Application No.: 09/986,021

For: PRODUCT APPLICATION
DEVICE INCLUDING A DIP TUBE

REQUEST FOR APPROVAL OF DRAWING CHANGES

FIG. 1

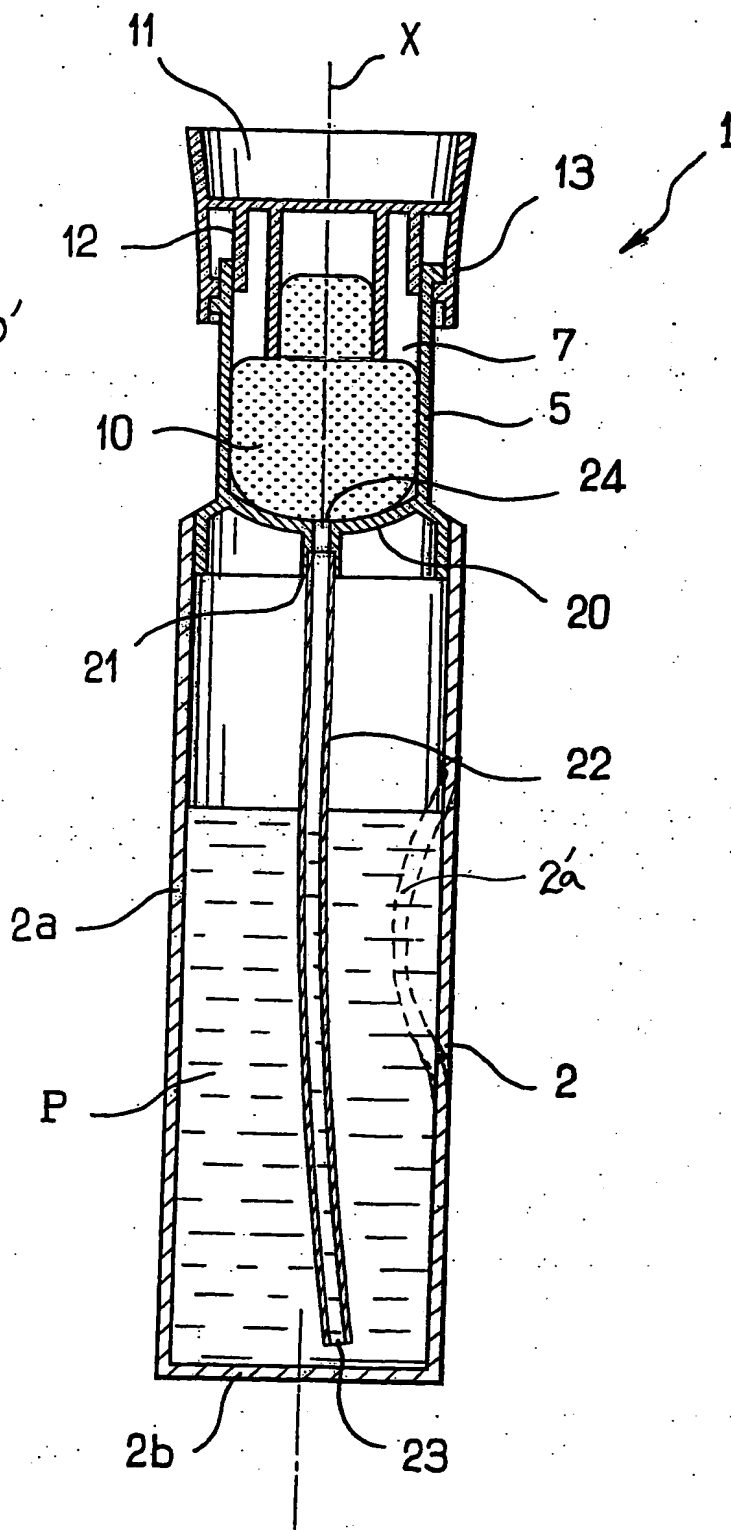
Subject to the approval of the Examiner, it is respectfully requested that Fig. 1 in the above-captioned application be amended by adding two dotted lines to show that the receptacle may comprise a flexible-walled receptacle. It is also respectfully requested that Fig. 1A be newly added to the drawings to show that the applicator element may comprise a foam formed of a plastic material. The changes are indicated in red on the attached copies of the formal drawings filed on March 27, 2002.
